MFN 08-858

Docket No. 52-010

Subject: Response to Portion of NRC Request for Additional Information Letter No. 236 Related to ESBWR Design Certification Application - Auxiliary Systems - RAI Number 9.4-29 S02

RAI Number 9.4-29 S02

Figure 1, CRHA EFU AIR SUPPLY- CONCEPTIONAL

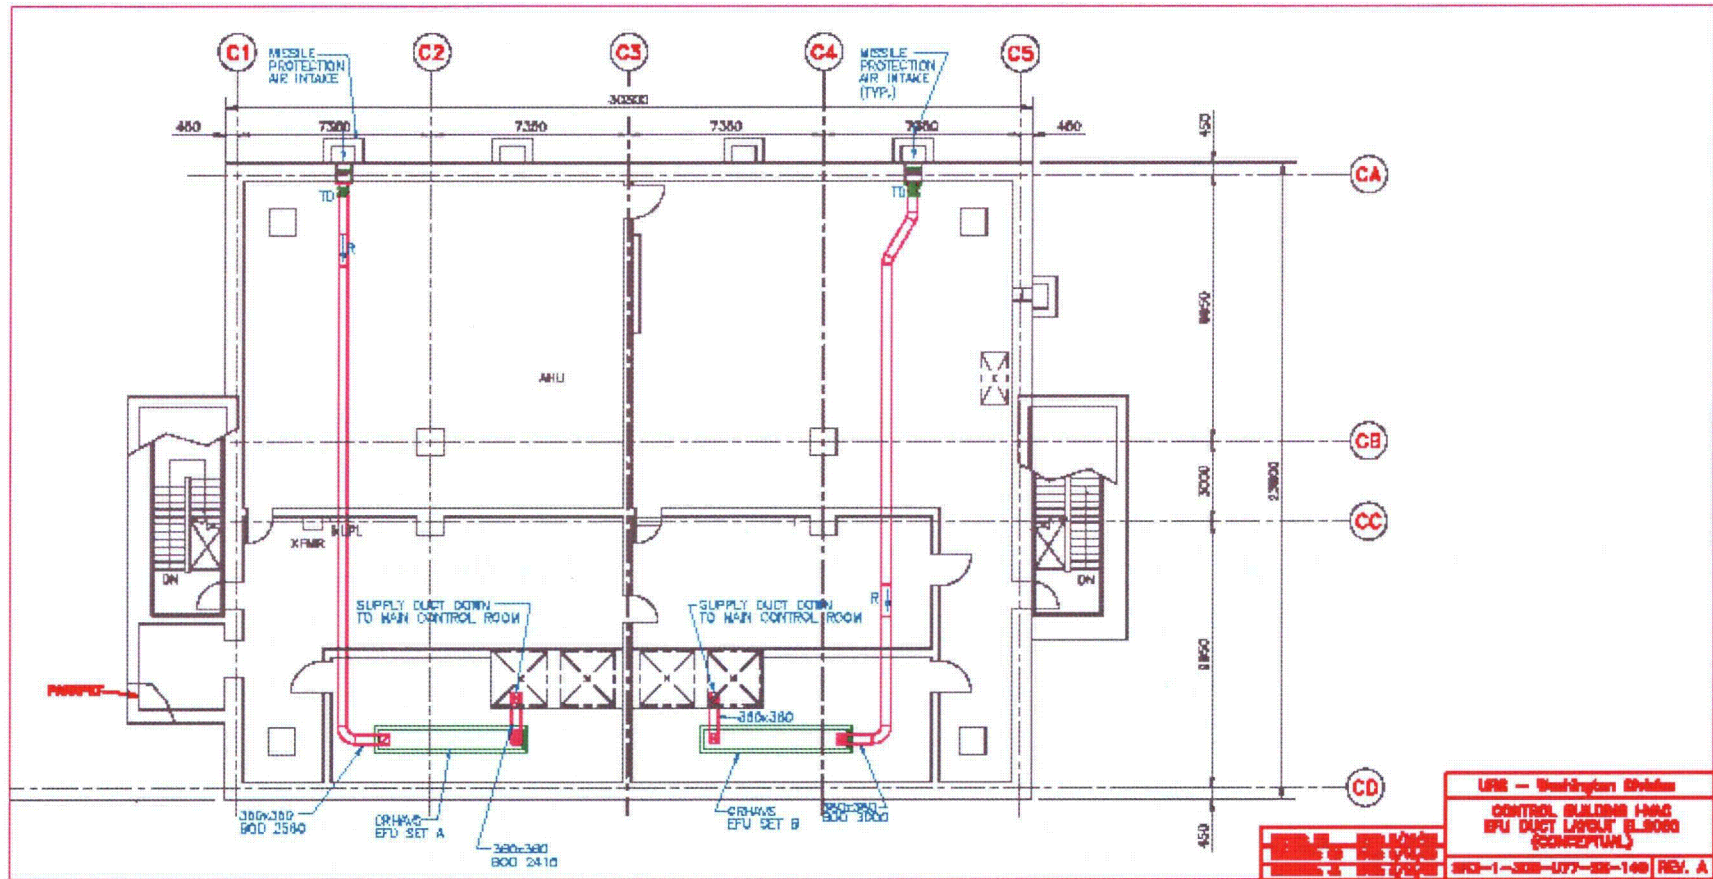
A. Please provide in the DCD sufficient design details to provide reasonable assurance that the air would mix uniformly by the EFU distribution to support the conclusion that the operators would have sufficient fresh air and that the assumption used in passive cooling analysis for uniform temperature in the control room is reasonable. A process flow diagram that shows EFU operation, flow rates, mixing of air capability and key controls would enhance the understanding in the DCD.

A. GEH believes that the DCD contains sufficient design details to provide reasonable assurance that the air would mix uniformly by the EFU to ensure that the operators would have sufficient fresh air and support the assumption used in passive cooling analysis for uniform temperature in the control room. As discussed in question C of this RAI response, considerable margin is available in the ESBWR CRHA design to prevent physical effects impacting control room operator performance and ensure the uniform temperature assumed for the passive cooling analysis. Carbon dioxide is the major concern with air stagnation and stratification. Carbon dioxide vapor is heavier than air and will

accumulate in low areas. Therefore, the variable orifice relief device located under the raised floor will be effective removing this contaminant. During emergency operations, all areas in the CRHA would not be continuously occupied. Minimal lighting and instrumentation available during emergency conditions would limit continuous occupancy to selected work stations in the main operation areas as recommended by NUREG 0700.

While a detailed process flow diagram is not available at this point in the system design process, Figure 3, EFU Air Distribution- Conceptual, attached to this RAI response, illustrates the duct and register layout visualizing the EFU air flow in the CRHA.

Figure 3, CO₂ Buildup for Isolated MCR

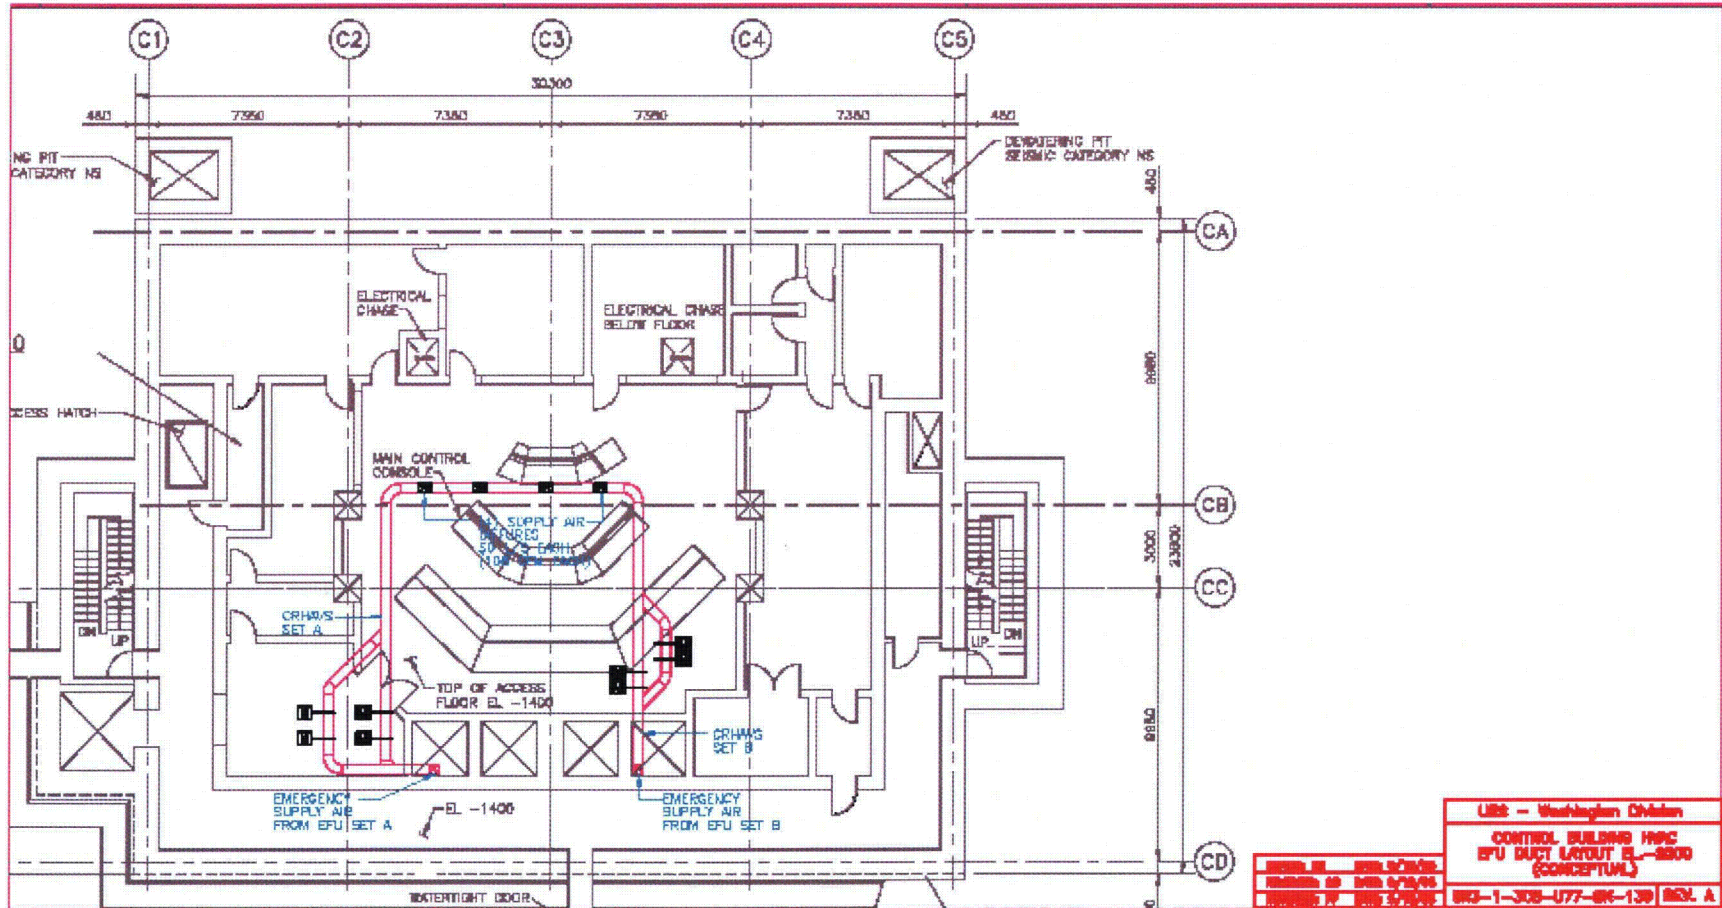
C. What defense in- depth measures are available to increase fresh air supply in the event that the air becomes stale and lacking in freshness?

C. Control Room Operator human performance will be ensured due to the margin provided by ESBWR CRHA design for CO₂ levels below those concentrations where human performance is impaired. Figure 3, CO₂ Buildup for Isolated MCR, illustrates that the CO₂ concentration in the ESBWR CRHA will not reach 5000 ppm for several days with five (5) CRHA occupants in a totally isolated control room, such as during an external fire or toxic gas event.
